<b>TAL-CO SUPPLEMENTAL INSTRUCTION #45</b>			
Project Name:	<b>RW TOMLINSON - NEW HEAD OFFICE</b>		
Project Location:	<b>100 CitiGate Drive, Ottawa, Ontario</b>		
ARCH. SI #:	<b>N/A</b>	Issued By:	<b>Chris Simpson</b>
STRUC. SI #:	<b>SSI #S20</b>	Date Issued:	<b>June 27, 2017</b>
MECH. SI #:	<b>N/A</b>	Revision #:	<b>N/A</b>
ELEC. SI #:	<b>N/A</b>	Revision Date:	<b>N/A</b>

**Title:** Deletion of Steel Plate On HSS at 3rd Floor Slab Level in Atrium

# STRUCTURAL SITE INSTRUCTION

TO: TALCO Building Innovations DATE: May 31, 2017  
ATTENTION: Chris Simpson EMAIL: csimpson@tal-co.com  
PROJECT: Tomlinson – New Building PROJECT No.: 15-0179  
ISSUED BY: Nas Torabi PAGES (Incl this one): 2  
STRUCTURAL SITE INSTRUCTION No.: 20

5 SECTION: 3rd FLOOR: ATRIUM GIRTS FRAMING  
 S201 SCALE 1:20

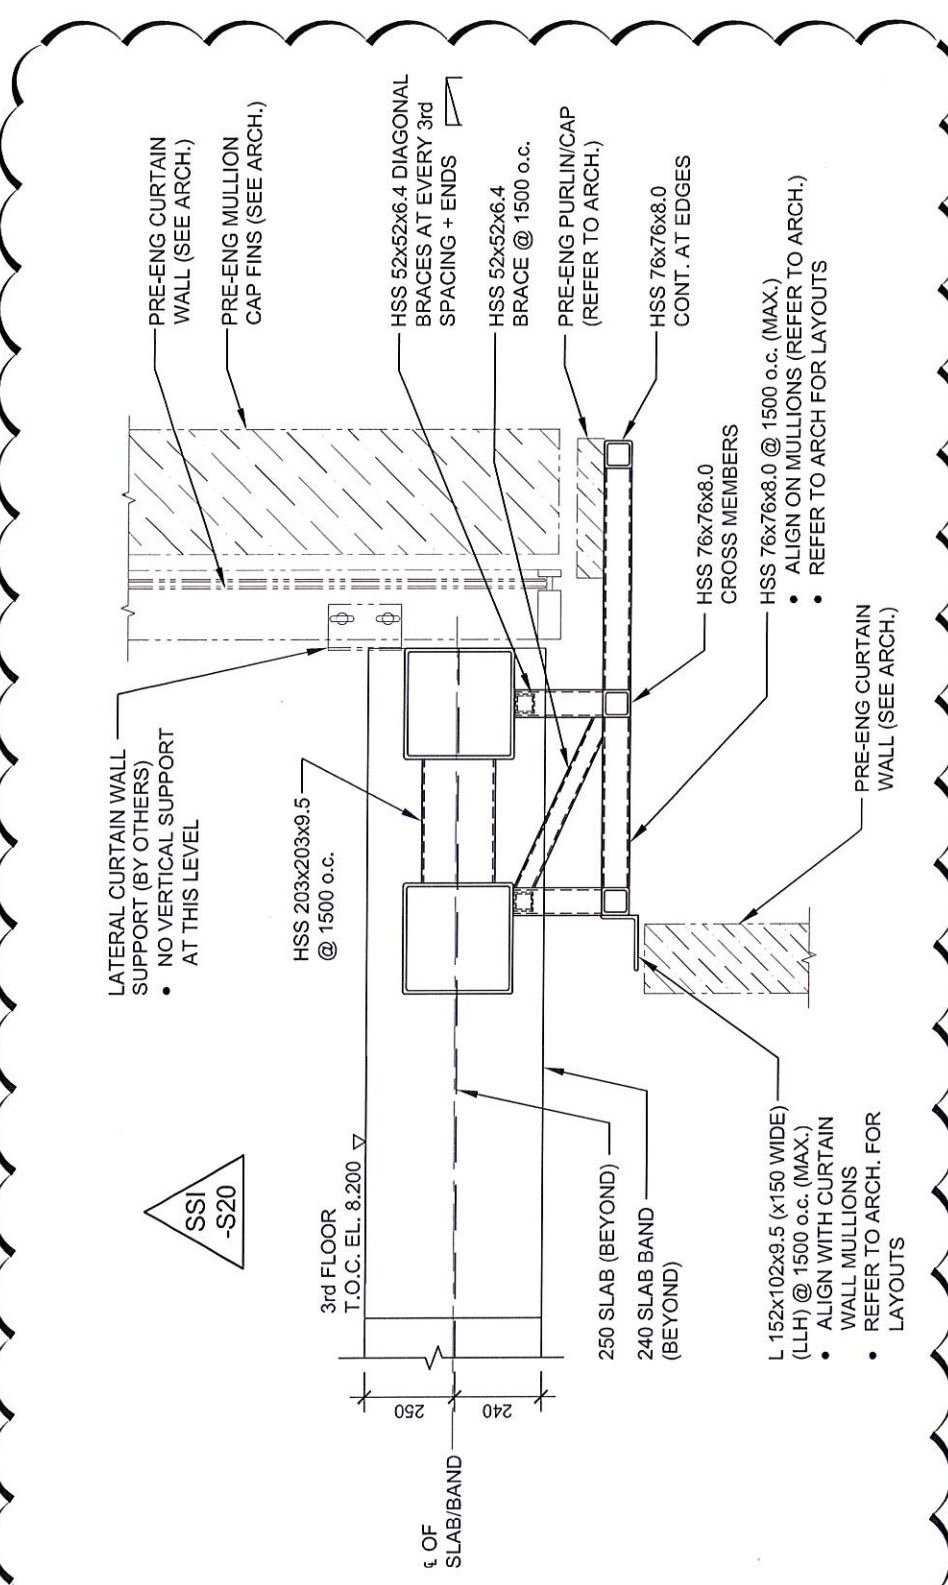
Delete steel plate from top of HSS at 3rd Floor Slab level East and West sides of Atrium

GC to revise the Section and delete the L38x38x6.4 and steel deck (indicated CJE's Sec.05/S201) and 3mm THK plate (indicated in CSA's Sec 12/A601).

Steel Plate has been deleted as per Architect's request for aesthetic purposes.
